# RFI 155 - Mixing Valve Clarifications

Date Submitted	2/2/2016	To Fred Hofmann	From Robert Bowman		
Date Required	2/9/2016	Rossetti	Morley Construction Company		
Discipline	Plumbing	Tel: (313) 463-5151	Tel: 310-399-1600		
Author RFI Ref.	None	fhofmann@rossetti.com	rbowman@morleybuilders.com		
Document Ref.	Number	Title	Revision		
	P-001	PLUMBING SCHEDULES, NOTES AND DETAILS	Aug 12, 2015 - No: 1		
P-211 P-212		PLUMBING GROUND LEVEL PLAN - NORTH	Nov 20, 2015 - No: 2		
		PLUMBING GROUND LEVEL PLAN - SOUTH	Sep 18, 2015 - No: 1		
	P-222	PLUMBING UPPER LEVEL PLAN - SOUTH	Sep 18, 2015 - No: 1

## January 2015 TM-186-520B-LF STSTL- REC Cabinet Assembly

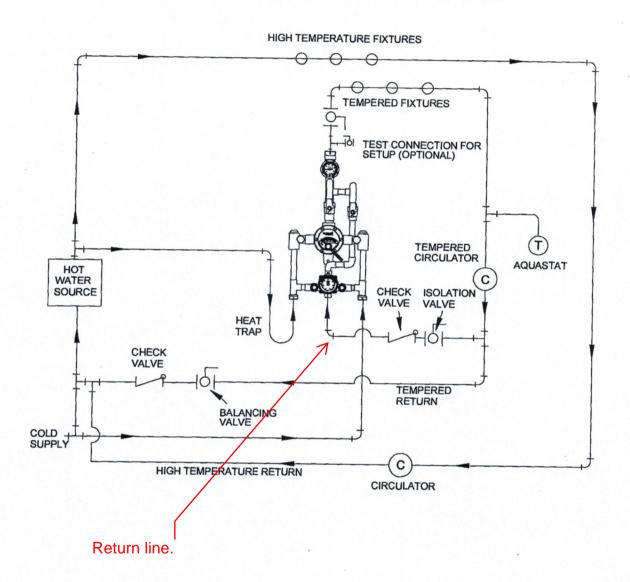
- 1. These mixing valve cabinets are 8" deep, and per the schedule on P-001 they are shown to be recessed. However, the walls at the locations indicated are less than 8". For each mixing valve, please clarify if it should be surface mounted, semi-recessed (if so, please provide recessed depth), or fully recessed (if so, please provide new wall type and wall dimensions).
- 2. Per the approved submittals (see attached) the mixing valves are shown with a return line, however this is not shown on the plumbing drawings. Please confirm if a return line is required.

2. The mixing valves serve only the shower valve and a return line shall not be required. Disregard piping method #2. GPM in each system varies.
